A Maharatna Company

Revision of the Indian Electricity Grid Code Suggestions

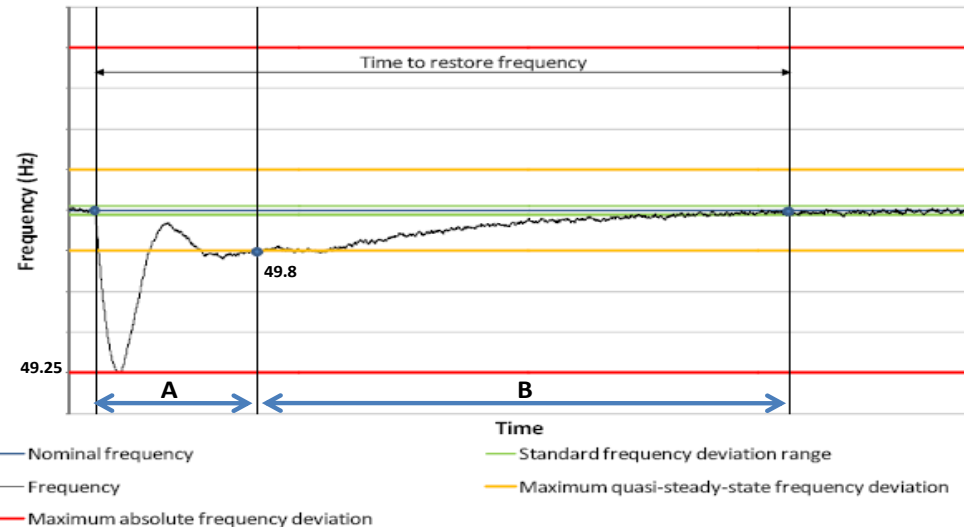
Freq. decline can be arrested to -0.15 Hz (quasi Steady State Freq. at 49.8 Hz) if Primary Up reserve or Governor control is ensured on units (synchronized to Grid) having total capacity of ~ 60,000 MW only out of in service capacity of ~ 100,000 MW even during high RE scenario of 2021-22.
